ARTICLE 727 — INSTRUMENTATION TRAY CABLE: TYPE ITC

3-502 Log #208 NEC-P03
(Article 727)**Final Action: Reject****Submitter:** David Wechsler, The Dow Chemical Company
Comment on Proposal No: 3-217**Recommendation:** Insert “or” following the end of the first sentence of the listing, and change the first line number from (1) to (2) as indicated below:

(Comment 3-638 (Log #3684))

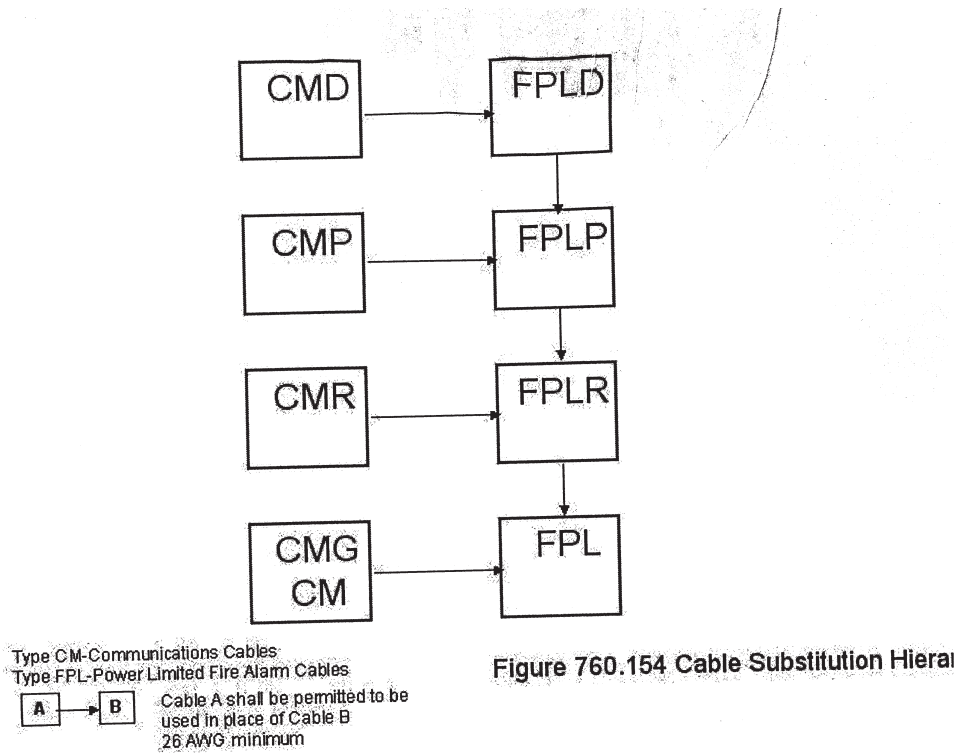
3-638 Log #3684 NEC-P03 **Final Action: Reject**
(760.61, 760-71, Figure 760-61 and Tables 760-61 & 760-71)

Figure 770.154 Cable Substitution Hierarchy

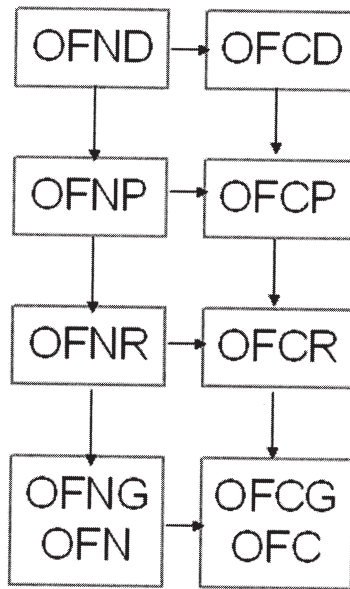
16-159 Log #2892 NEC-P16 **Final Action: Reject**
(770.51, 770.53, Figure 770.53, Table 770.50 & 770.53)

FPN: Cable types are listed in descending order of fire resistance rating. Within each fire resistance rating, nonconductive cable is listed first, since it may substitute for the conductive cable.
